**RE: REQUEST (CLAIM) ON THE PROPOSED BUJAGALI
HYDROPOWER AND INTERCONNECTION PROJECT IN
UGANDA.**

AFRICAN DEVELOPMENT BANK CLAIM ON THE BUJAGALI DAM PROEJCTS IN UGANDA

An Analysis of Power Planning Associates’ “Bujagali II – Economic and Financial Evaluation Study – Final Reports”

Analysis of Lake Victoria and The Proposed Hydrological Curve Change

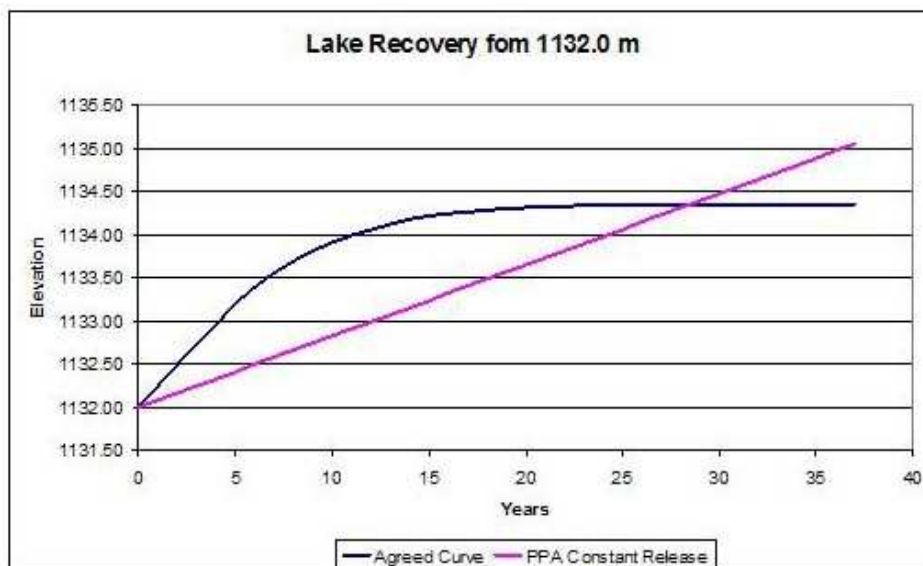
The graph above shows that the Agreed Curve allows the lake level to recover more quickly than with the PPA proposed outflow regime. The graph looks at how Lake Victoria would recover from a baseline level of 1132.0 m (a low level that was experienced late last year) during 35 years of constant average inflow (average net basin supply "NBS" 1900-2005 computed in the PPA report). As the graph shows, the Agreed Curve releases would restore the lake to a relatively "normal" level within about six years, while the Constant Release flow will not reach that level for close to 18 years. The Agreed Curve response is more representative of a naturally functioning lake, as opposed to the PPA regime, which resembles the filling of a reservoir.
